Access Compliance Report

Public Rights-of-Way

Intersection ID: N/A	Main Street: HEDGEWYCK_PL	Cross Street: N/A	Location: NE
ADA ID: 7171DD8C16E5	Ramp Type: BlendTrans2	Initial Pass/Fail: Fail	Overall Compliance: No
		Severity Score: 12.5

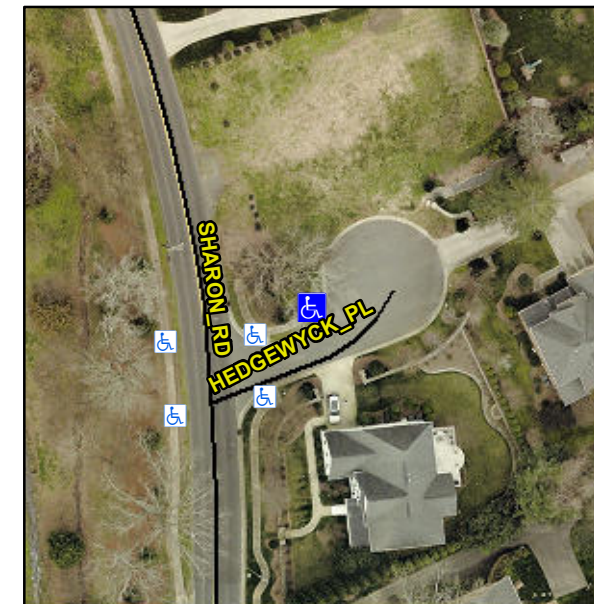
R304.5.3

Remove & Replace Curb Ramp With Two New Directional Ramps or Equivalent.
